**PRELIMINARY SAFETY EVALUATION REPORT**

**TRANSNUCLEAR, INC.**

**STANDARDIZED ADVANCED NUHOMS<sup>®</sup> HORIZONTAL MODULAR STORAGE**

**DOCKET NO. 72-1029**

**FSAR Figure B.1.1-2  
NUHOMS® 32PTH2 DSC**

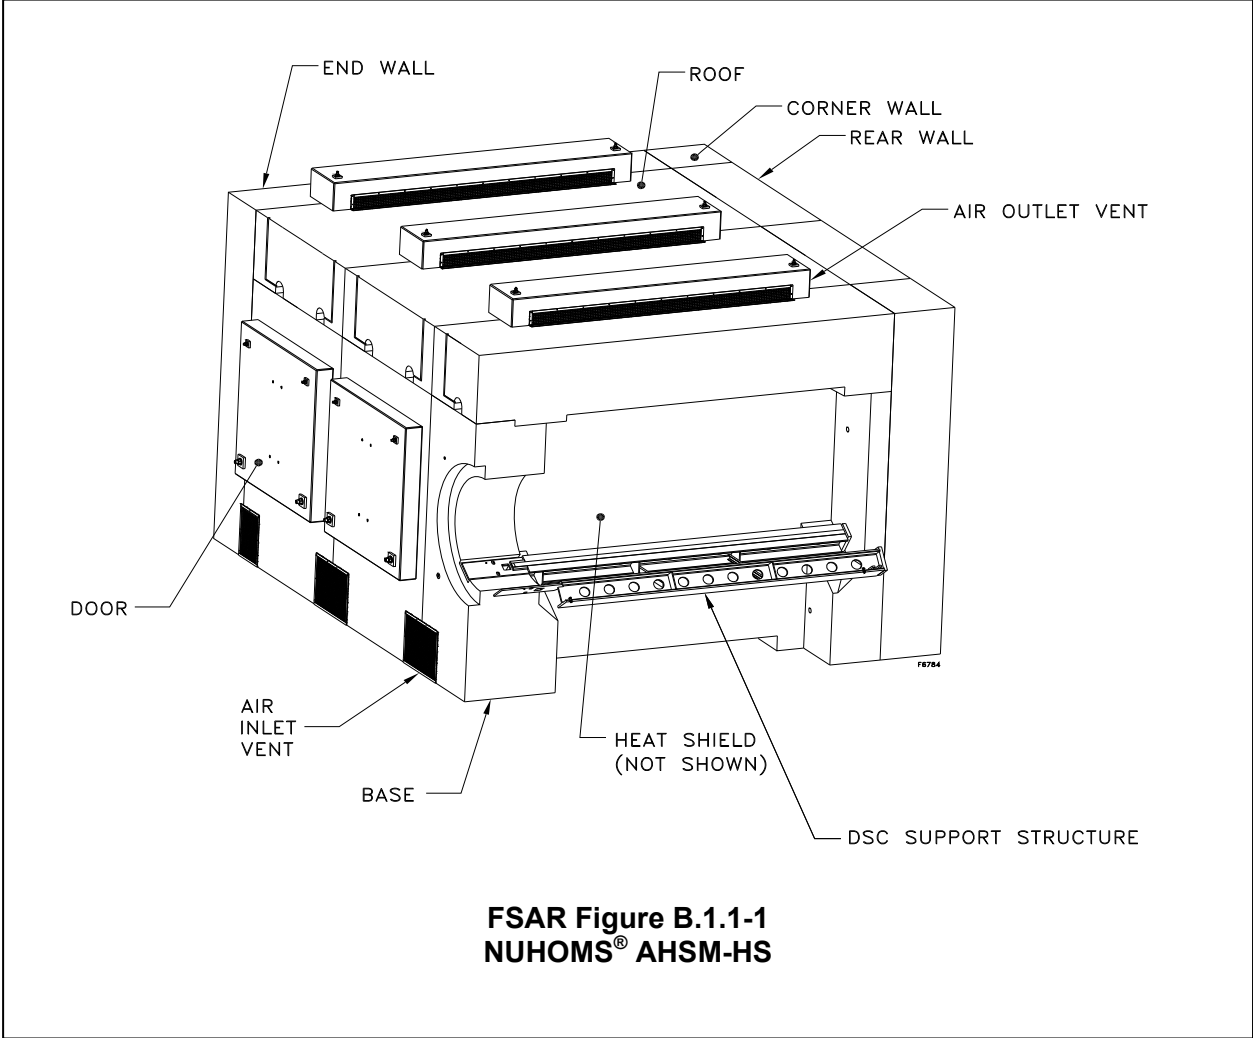
The confinement boundary (shown in FSAR Figure B.3.1-2) consists of the cylindrical shell, top and bottom inner cover plates, the vent and siphon block, the vent and siphon cover plates and associated welds. The outer top cover plate provides a redundant confinement boundary. The DSC shell thickness is 5/8" and has only one cavity length option of 178.65 inches. The weight of a fully loaded DSC is 106,000 lbs, as listed in FSAR Table B.3.2-1. FSAR Section B.3.1.1.1
